Re: State of California – Public Utilities Commission

General Order 112-E Gas Audit – PG&E's Burney District

The Safety and Enforcement Division (SED) conducted a General Order 112-E audit of PG&E's Burney District from August 26-30, 2013. On December 2, 2013, the SED submitted its audit report, identifying violations and findings. Attached is PG&E's response to the CPUC audit report.

Figure 1: Excerpt of Ruby Interconnect Survey Map with indicated depths (See Attachment O)

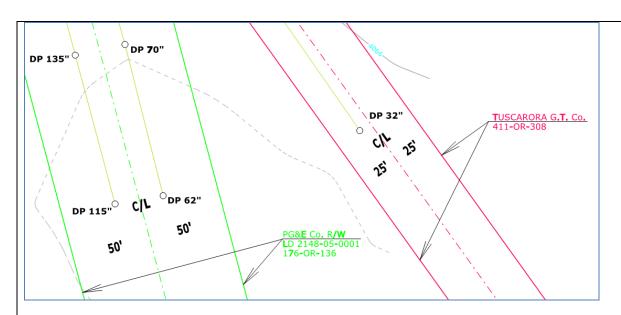
CPUC	SED asked for documentation to demonstrate clearance from substructures as required
Finding	by §192.325 for the installation at the Ruby Pipeline Intertie, but the information could
	not be provided by the end of the audit. Please provide SED with this documentation.

In the preliminary stages of designing the job, a land survey is performed to collect data on marked underground facilities, topography, and any other above ground obstructions (See Figure 1 below). This data is delivered to the estimating or design and drafting to be incorporated in design drawings.
